URGENT FIELD SAFETY NOTICE

System: Aplio 500
FSCA-identifier : PS EU 8201
Type of action: Notice about the safety issue and corrective action

Date: 06/06/2017

**FIGURE 1 COMPARISON OF MPG VALUES
(A: SPLINE TRACE, B: CONTINUOUS TRACE)**

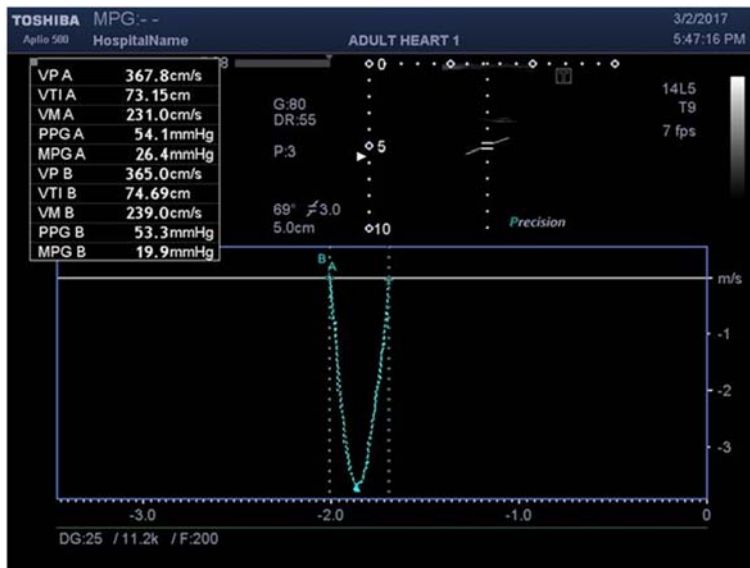
It has been reported that when velocity trace measurement is performed using Continuous Trace, the displayed MPG (mean pressure gradient) value may be substantially lower than that obtained by spline tracing in the diagnostic ultrasound system models and the ultrasound workstation models listed above. As a result, impaired function of the cardiac valves may be overlooked or normal cardiac valves may be incorrectly assessed.

The problem occurs when velocity trace measurement is performed on image data acquired in PW mode or CW mode, and Continuous Trace is used for tracing Doppler waveforms.

The improved software will be installed to prevent the occurrence of this problem.

Until modification is performed, do not use Continuous Trace as the tracing method for velocity trace measurement when calculating the MPG (mean pressure gradient) value. Instead, use Range, Spline Trace, or Line Trace as the tracing method. Refer to the operation manual <Measurement volume> provided with the system for the procedures for changing the preset for the tracing method selected automatically at the start of measurement or for changing the tracing method during measurement.
